ATTACHMENT I
DUKE POWER COMPANY
MCGUIRE NUCLEAR STATION
PROPOSED TECHNICAL SPECIFICATION REVISION
CONTAINMENT ICE BED WEIGHT

3/4.6.5 ICE CONDENSER

ICE BED

ATTACHMENT IIa
(Sheet 1 of 5)

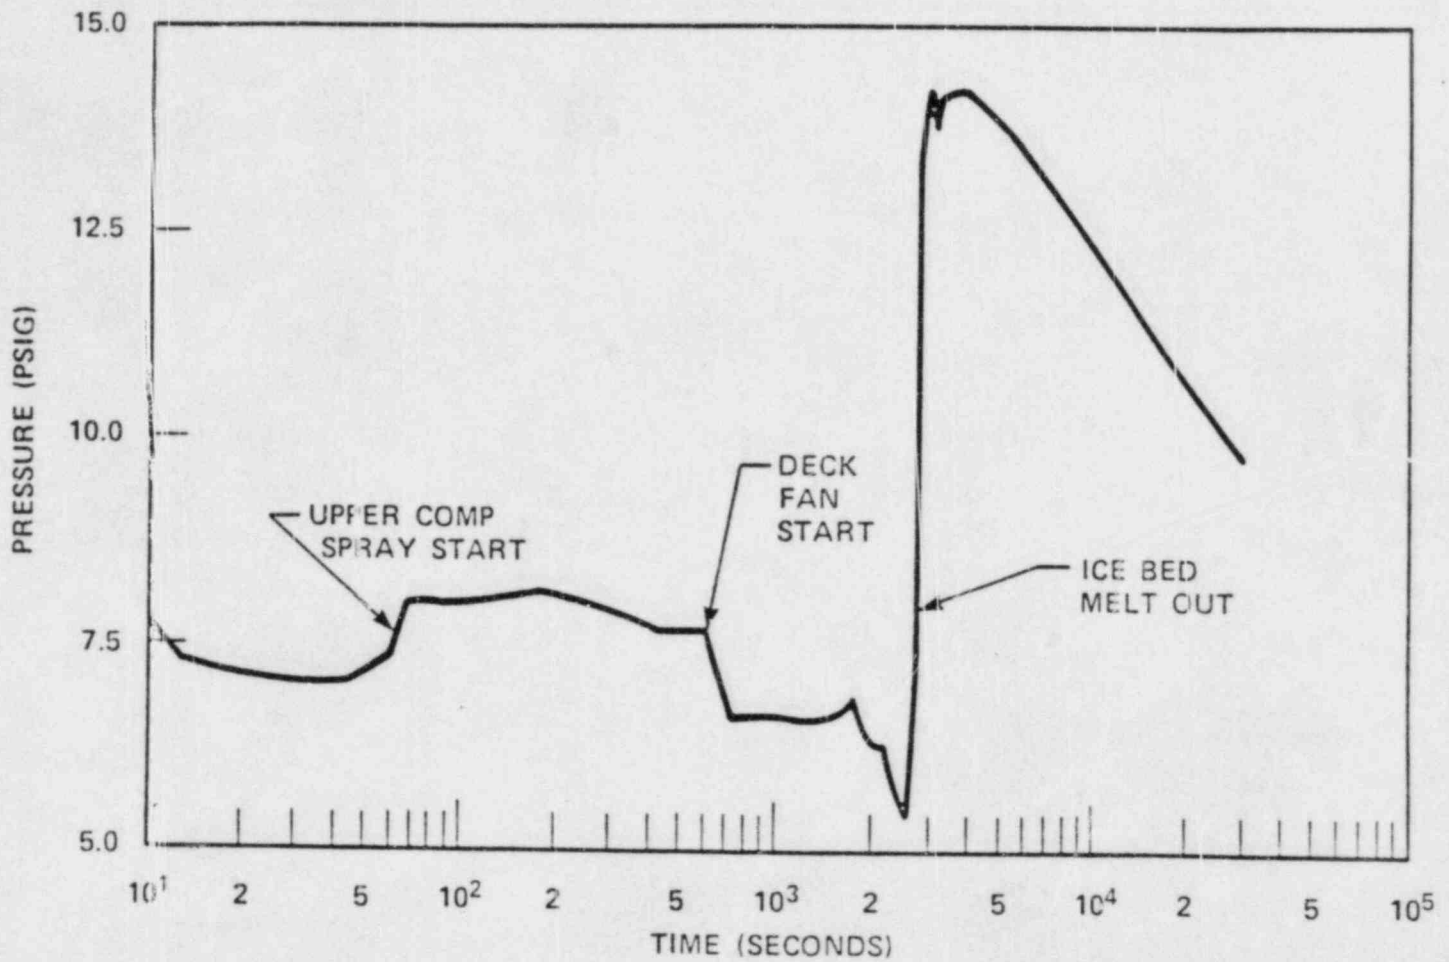
The previous calculation assumed an ice weight of 2.22×10^6 lbs in the containment and partial RHR flow diversion to the containment sprays at 3590 seconds following a LOCA event. Westinghouse performed a reanalysis of the Containment Pressure Calculation assuming an ice weight of 2.12×10^6 lbs and partial RHR flow diversion to the containment sprays at 3000 seconds instead of 3590 seconds assumed in the earlier calculation. The RHR flow diverted to the sprays is 1623 gpm for both calculations. It should be noted that the core temperature transient is over relatively early (within 400 seconds) during a LOCA event and the core temperature considerations have no bearing on the Containment Pressure Calculation. The Westinghouse reanalysis establishes that earlier diversion of the RHR flow to the containment sprays is more effective in controlling the containment pressure transient. The net result of the calculation assumptions of 2.12×10^6 lb of ice and diversion of RHR flow to the sprays at 3000 seconds after LOCA is an earlier ice bed melt out (at 2715 seconds instead of 3139 seconds) and a slightly reduced containment peak pressure (14.7 psig vs. 14.8 psig). The peak pressure is attained earlier at 3354 seconds instead of at 3599 seconds.

Attached figures (Attachment IIa) provide the containment pressure and temperature response to the design basis transient with reduced ice weight (2.12×10^6 lbs) and revised assumptions regarding earlier RHR spray actuation (at 3000 seconds).

(Sheet 5 of 5)

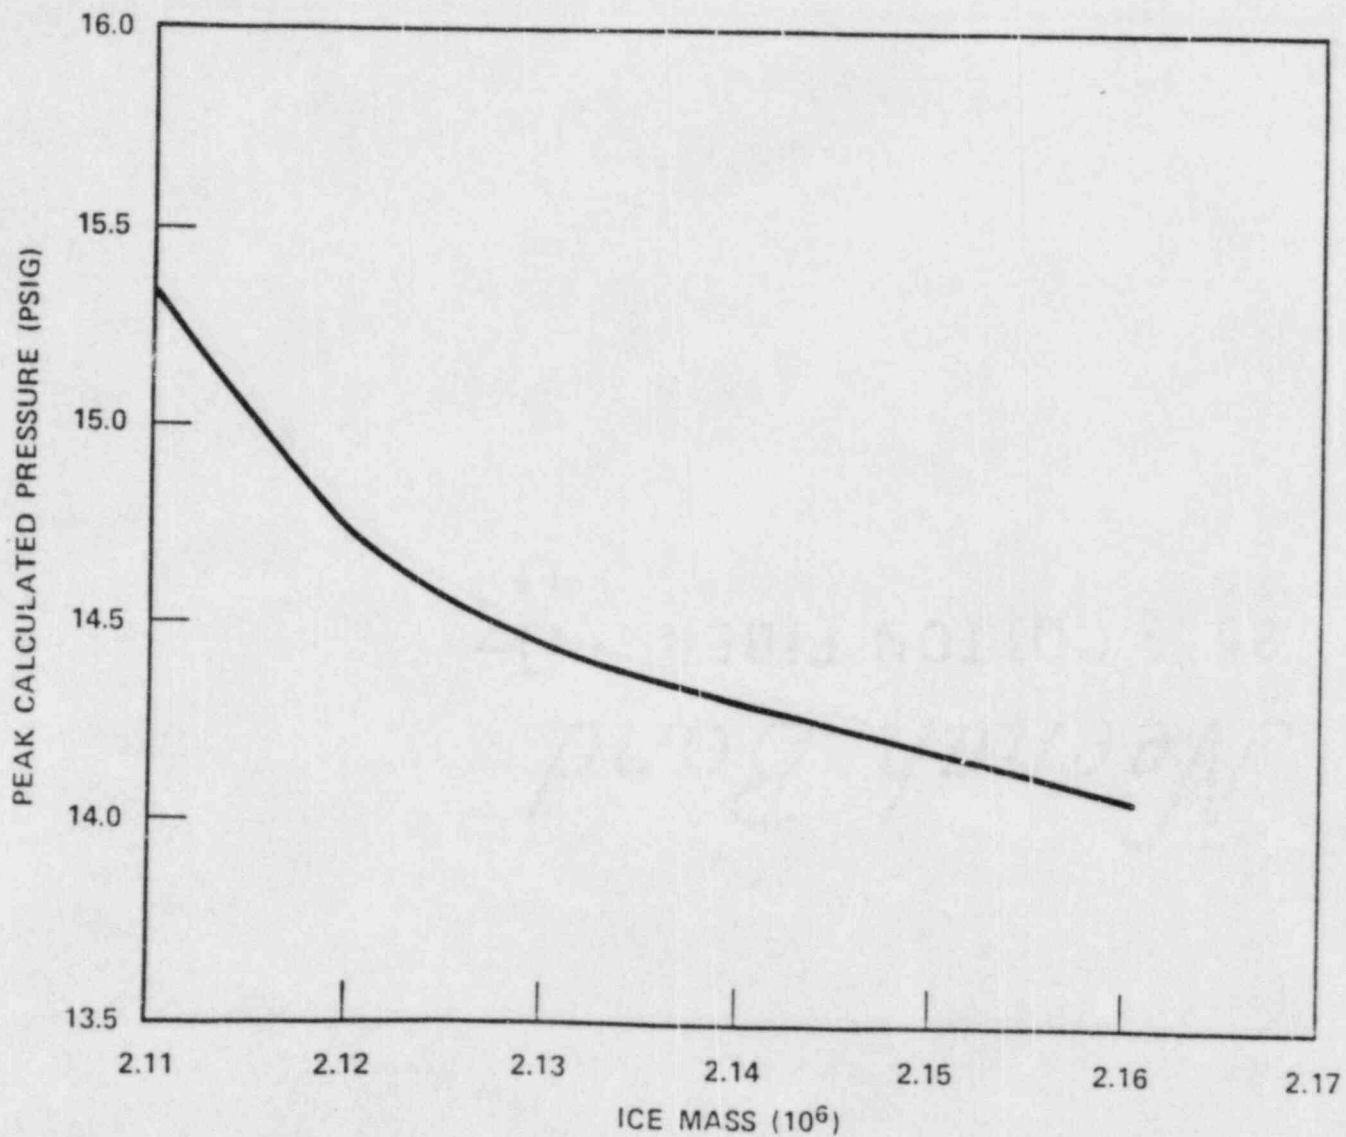
The Westinghouse reanalysis of the Containment Pressure Calculation provides the justification of reducing the ice weight in the containment to 2,355,320 lbs and changing the plant operating procedures to institute an earlier RHR spray actuation during a LOCA event. The proposed ice weight Technical Specification (3/4.6.5.1) of 2,355,320 lbs maintains the 10% conservative allowance for ice loss through sublimation and 1% allowance to account for systematic error in weighing instruments.
